Appl No. 09/812,260
Amtd. dated February 10, 2005
Reply to Office action of January 19, 2005

Amendments to the Drawings

ANNOTATED SHEET SHOWING CHANGES

Fig. 3

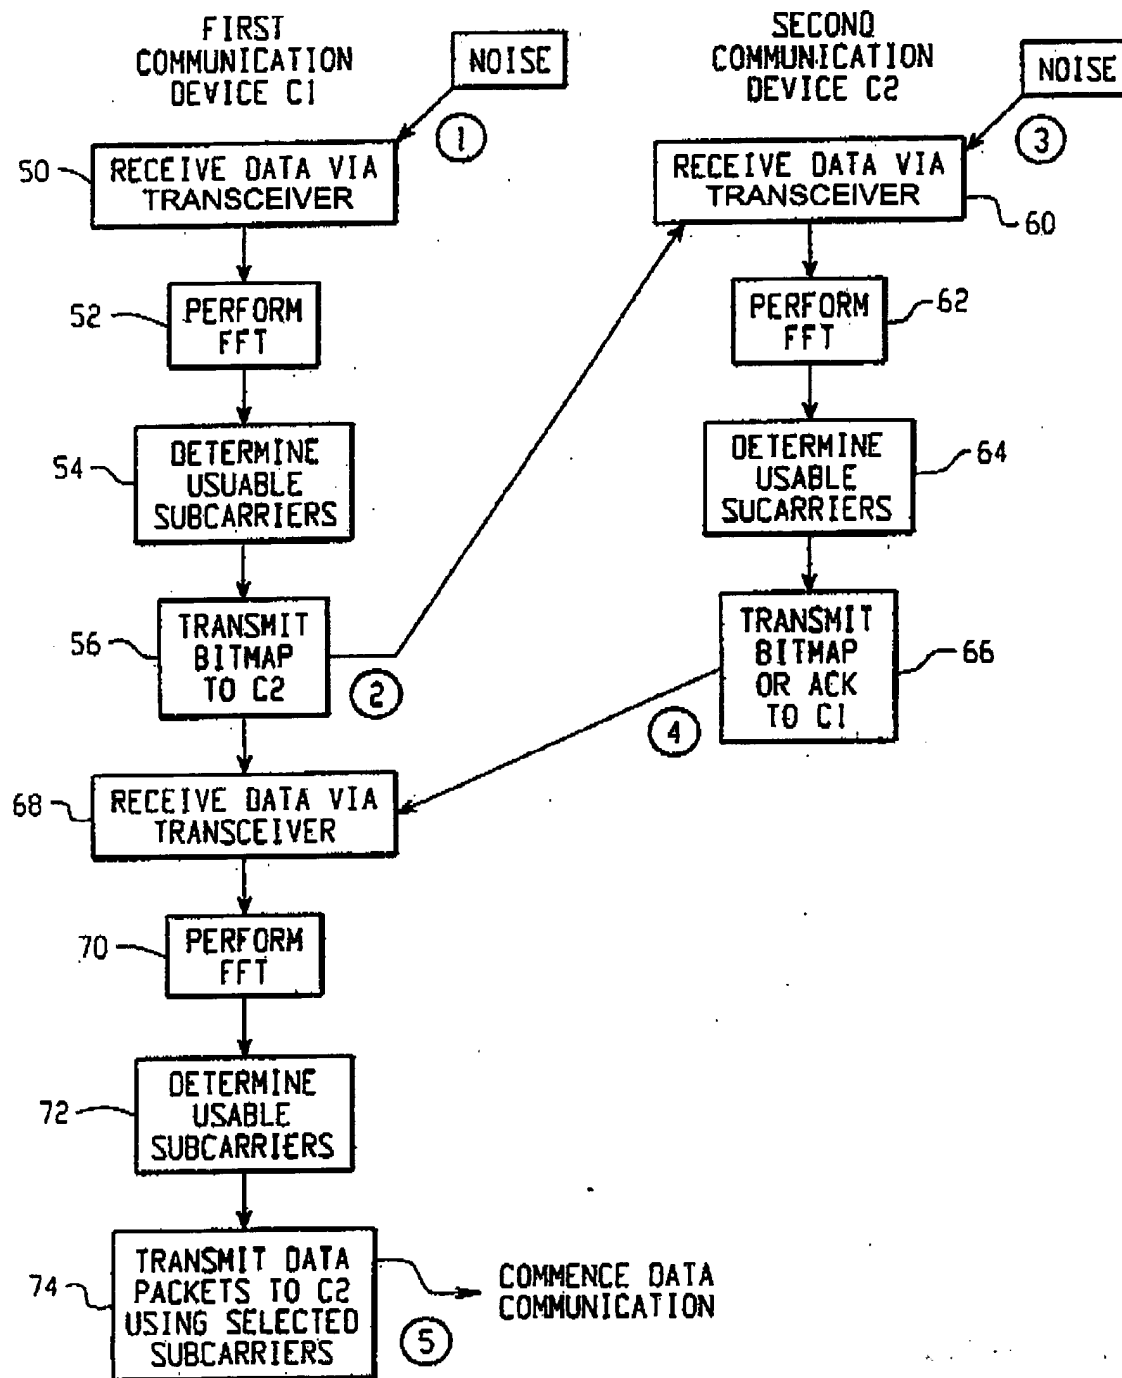
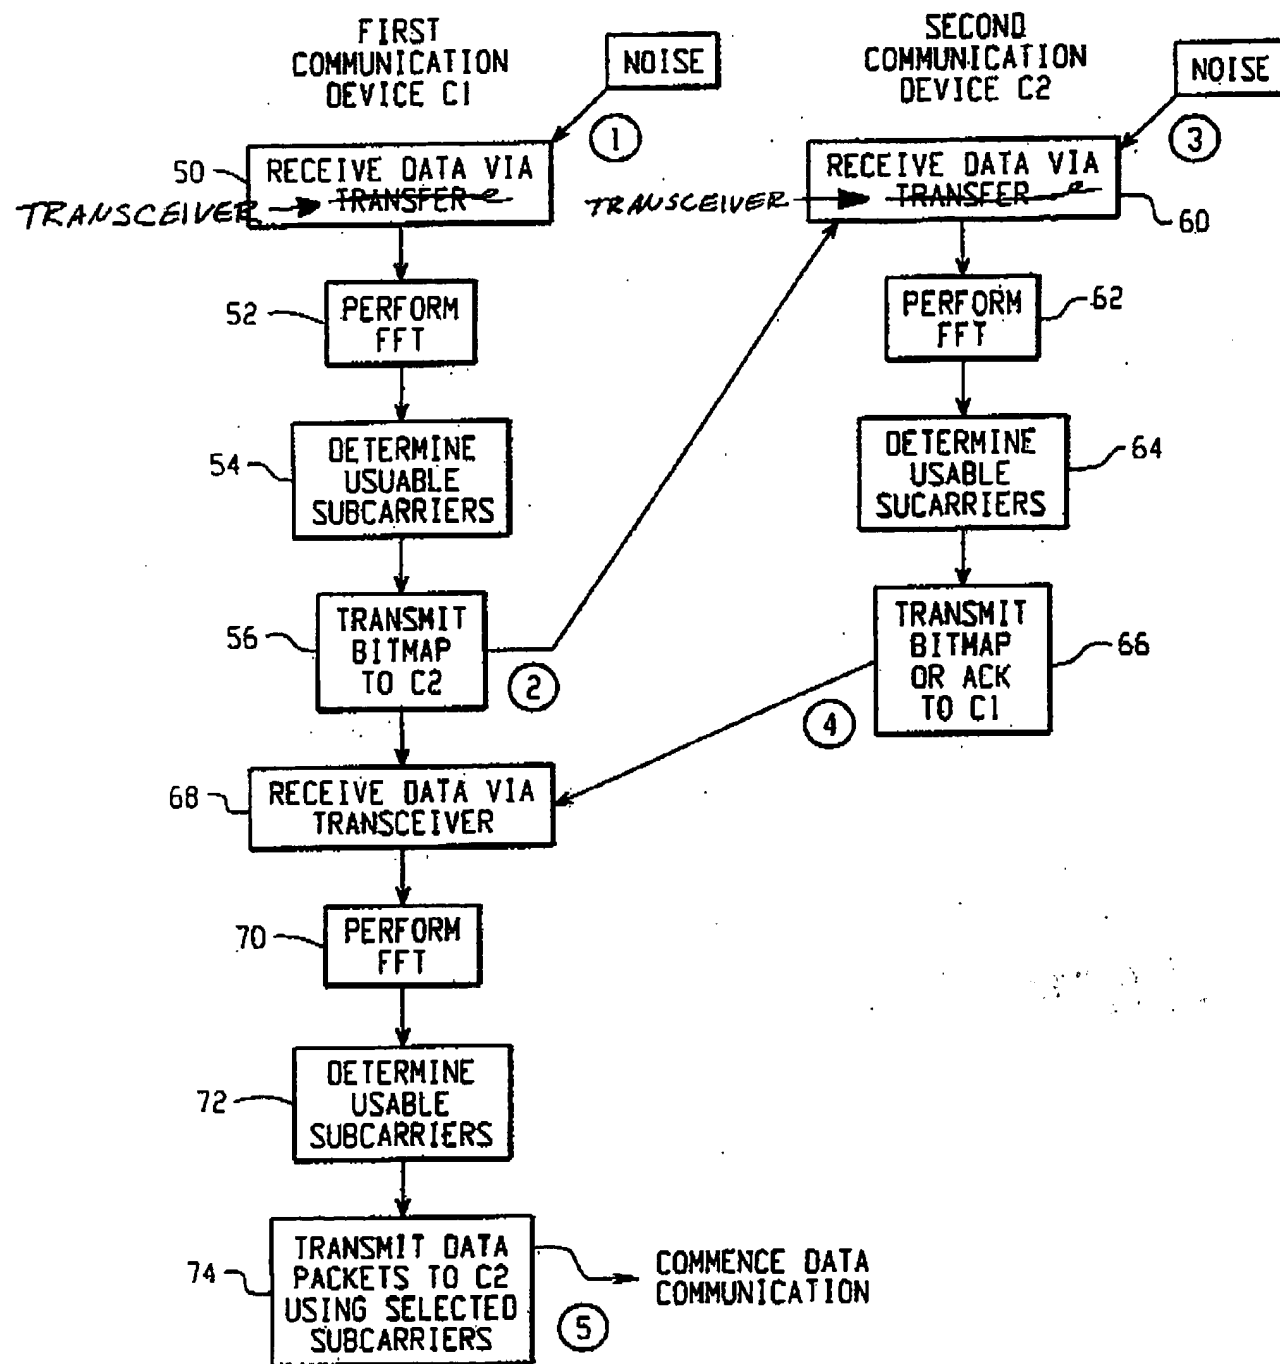
The attached sheet of drawings includes changes to Fig. 3. This sheet includes Fig. 3 and replaces all prior sheets including Fig. 3. In the previously submitted sheet, steps 50 and 60 erroneously recited "transfer" instead of "transceiver." The replacement sheet corrects this problem. The original Fig. 3 submitted with the application recites "transceiver" for steps 50 and 60.
